# UNITED STATES PATENT AND TRADEMARK OFFICE

APPLICATION NO.	FILING DATE	FIRST NAMED INVENTOR	ATTORNEY DOCKET NO.	CONFIRMATION NO.
10/551,354	06/21/2006	Paul R. Smith	593458001US	6414
25096	7590	08/06/2008	EXAMINER	
PERKINS COIE LLP			CHARLES, MARCUS	
PATENT-SEA				
P.O. BOX 1247			ART UNIT	PAPER NUMBER
SEATTLE, WA 98111-1247			3682	
			MAIL DATE	DELIVERY MODE
			08/06/2008	PAPER

<b>Office Action Summary</b>	<b>Application No.</b>	<b>Applicant(s)</b>	
	10/551,354	SMITH ET AL.	
	<b>Examiner</b>	<b>Art Unit</b>	
	Marcus Charles	3682

## **DETAILED ACTION**

FIG 2

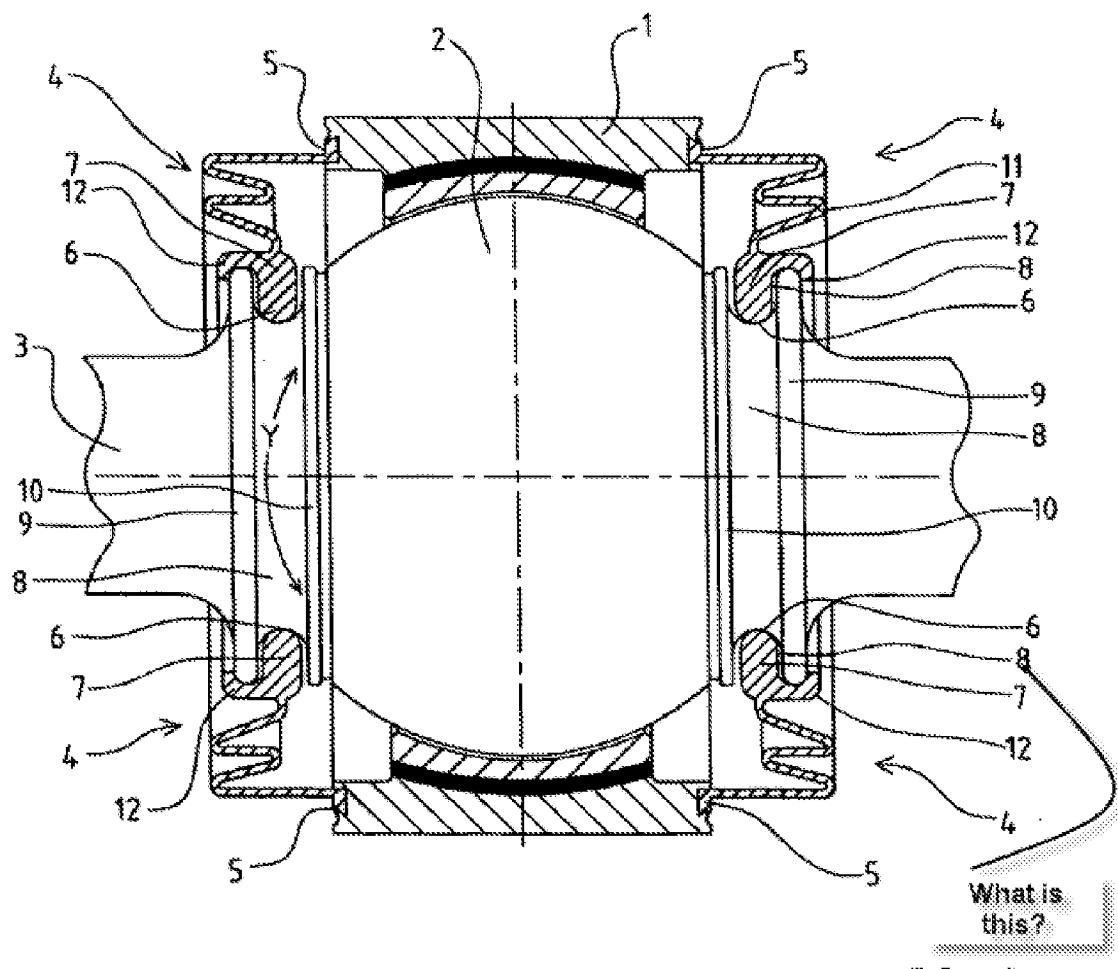
In addition, in figures 2 and 3, it is not clear as to what the reference "8" (the upper and lower right side) is depicting. Note the drawing illustration below only depict "8" at the lower right side.

The drawing fails to show or depict the "gap" as in claim 6.

The drawing does not show the line and the gap set forth in claim 6 and specify in the disclosure. Appropriate correction is required.
